# Updated Compressor Design: 6512480

TECH TIP

#204

gpd now offers an updated compressor design for 6512480 for:

### UPDATED DESIGN

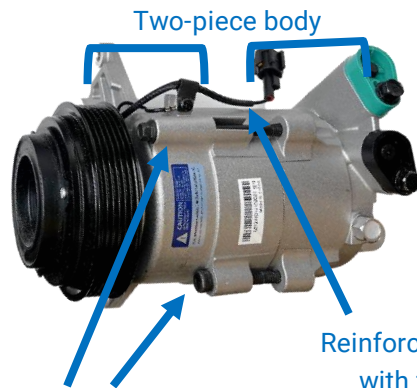
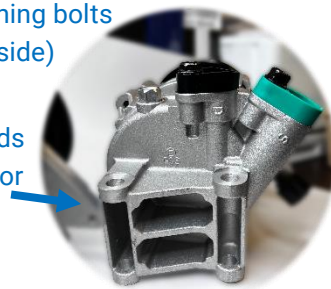
- Reinforced electrical connector with flexible wiring cover
- Two-piece body design vs. previous three-piece body design
- Four exterior body bolts vs. previous body design with five interior bolts
- Rear redesigned to protect rear studs/bolts

Redesigned as a two-piece body with four external fastening bolts.

Four external fastening bolts  
(Two on each side)

No visible studs/bolts  
on rear of compressor

Fastening bolts not visible on exterior

Studs/bolts visible  
on rear of compressor
